## PLANNING COMMISSION MEETING STAFF REPORT

**AGENDA ITEM**: Southill Phase 3 Final Approval

Southill Phase 3 PUD - Final Review

## Southill Phase 3 Final Approval

NORTH DITCH PLAN & PROFILE STA 10+00 - 12+00

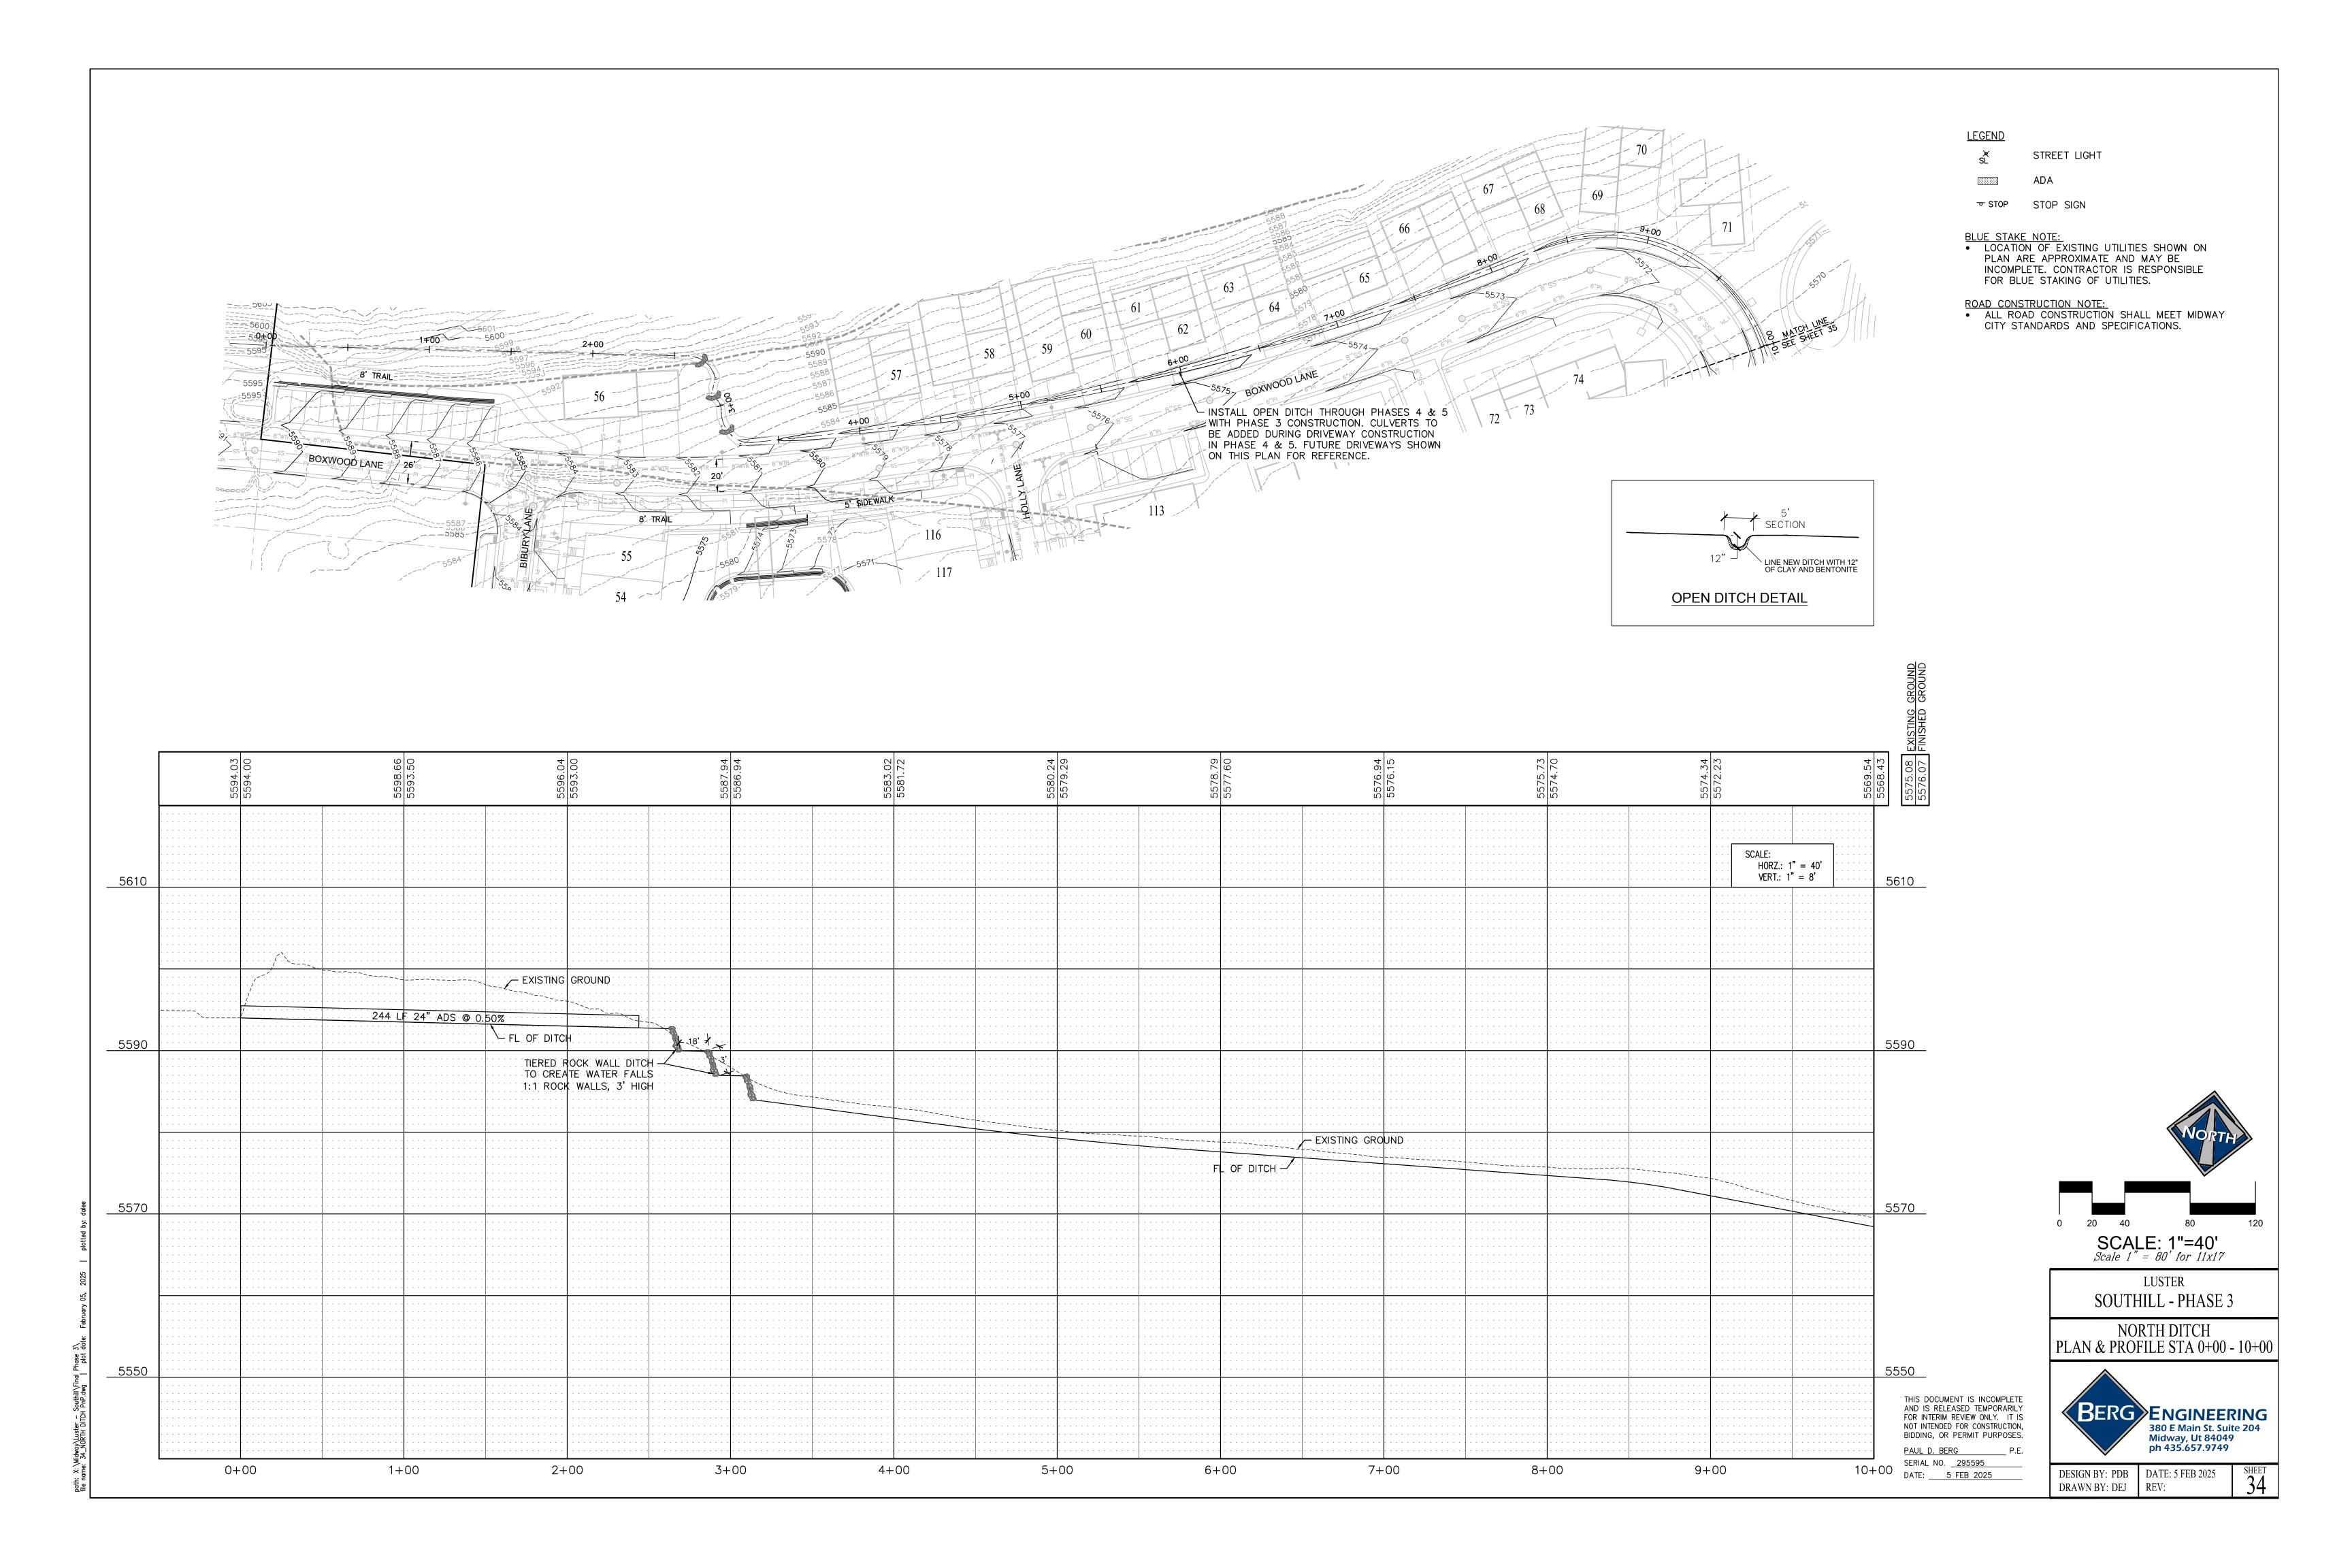
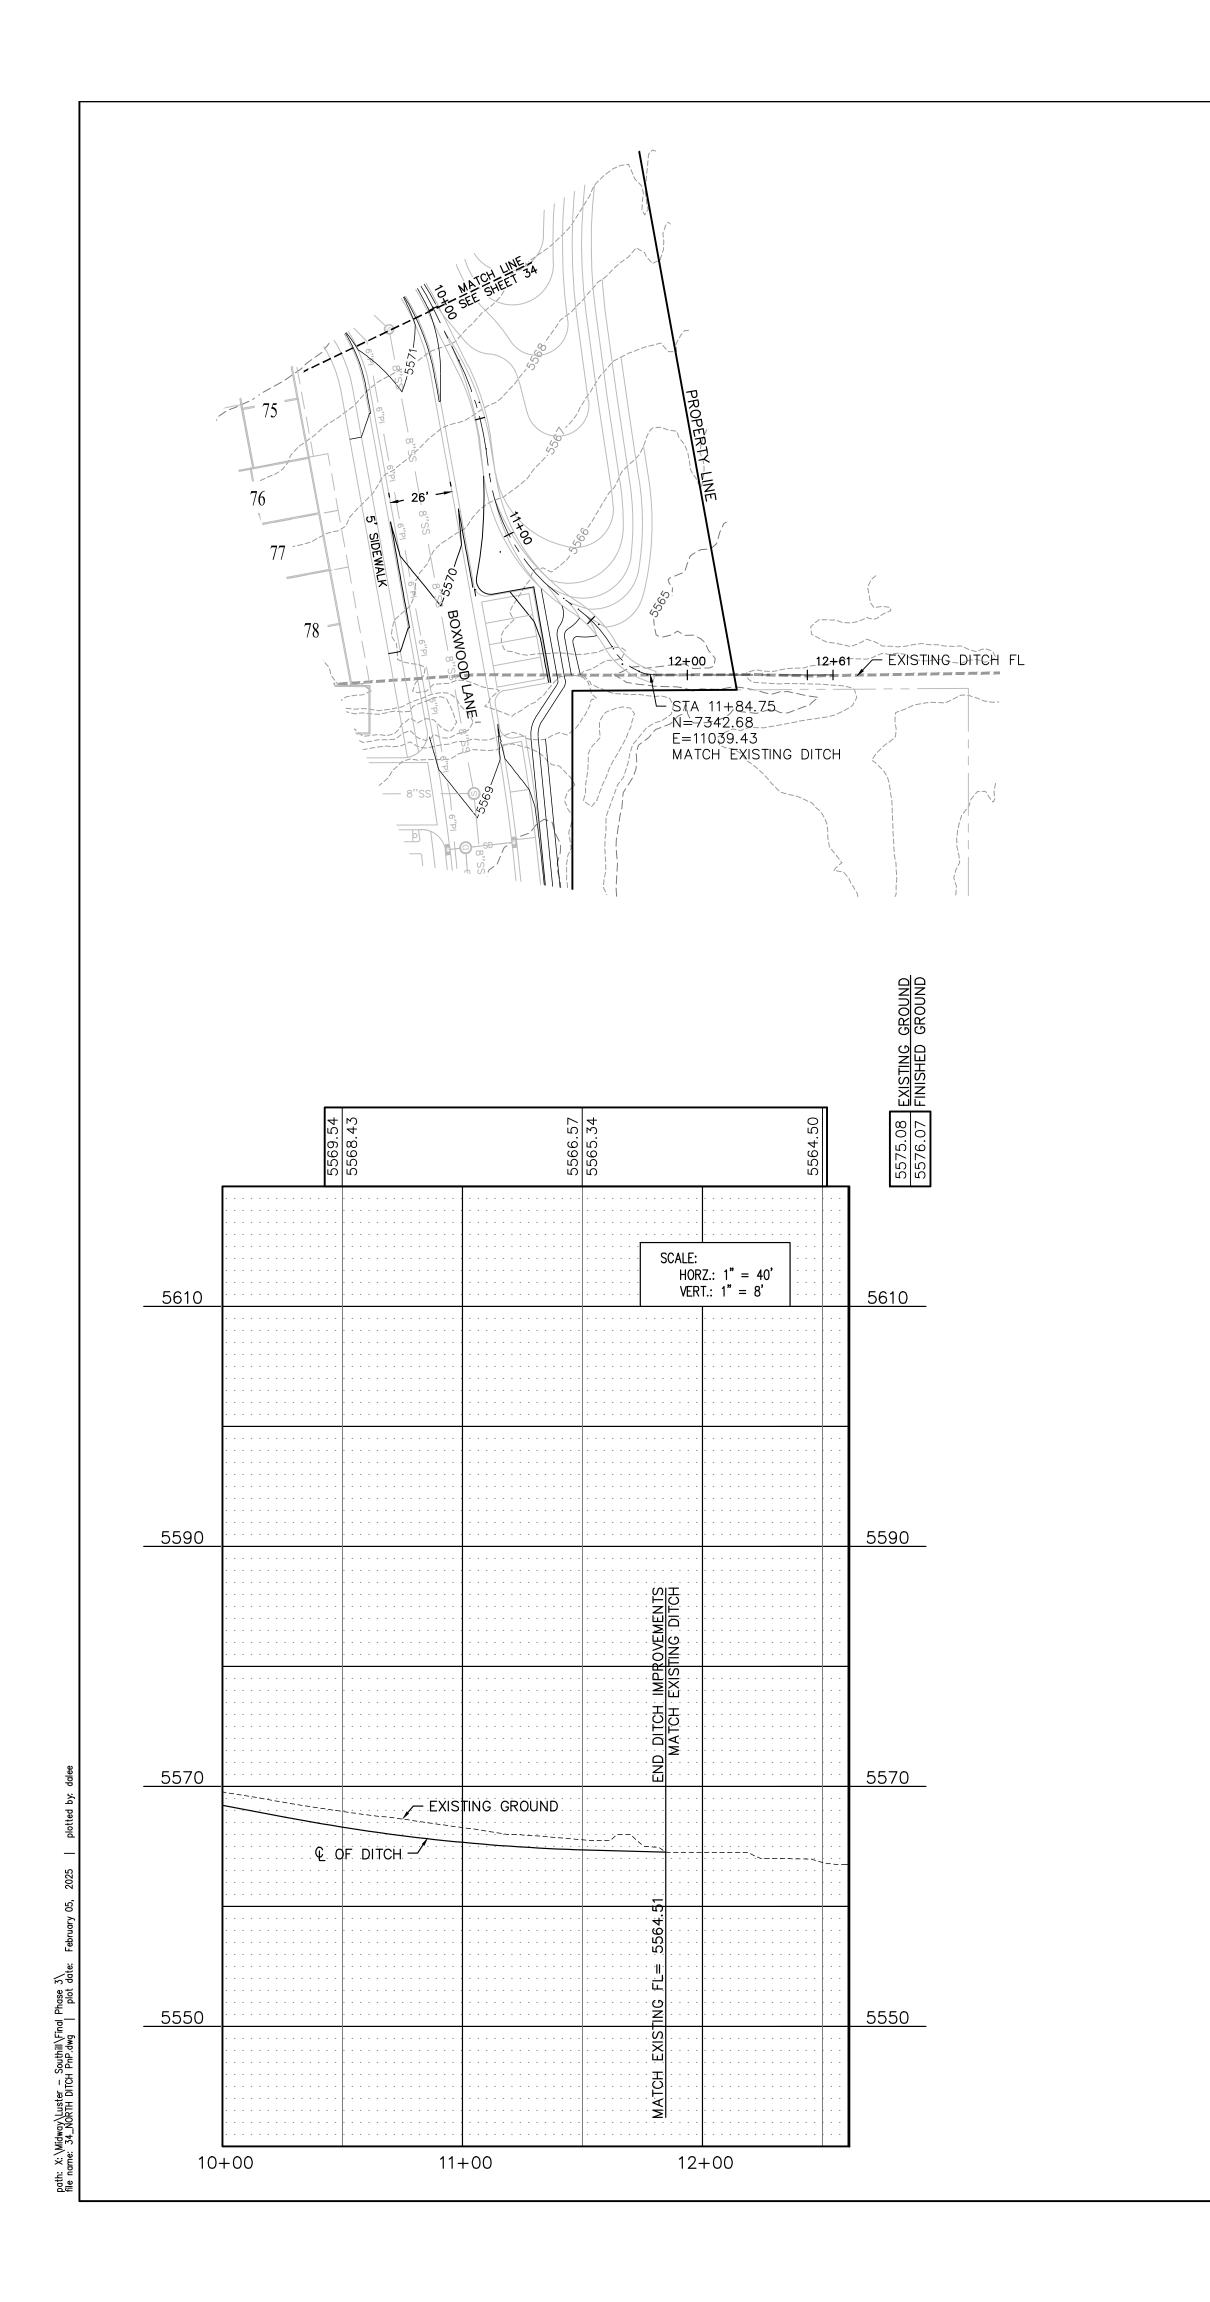
*Midway Irrigation Company Ditch* – There is an existing Midway Irrigation Company ditch that runs west to east across the property. The proposal is to reroute the ditch through parts of phases 3, 4, and 5. Midway Irrigation Company will need to review the plans and approve them before the ditch can be relocated.

- The subdivision will be serviced by the Midway Irrigation Company.
- There is a ditch towards the north end of the property that flows west to east. The ditch is proposed to be placed in a network of culverts and open ditch as it flows under driveways to the east side of the development. All proposed work on this ditch must be approved by the Midway Irrigation Company.

LINE NEW DITCH WITH 12" OF CLAY AND BENTONITE OPEN DITCH DETAIL
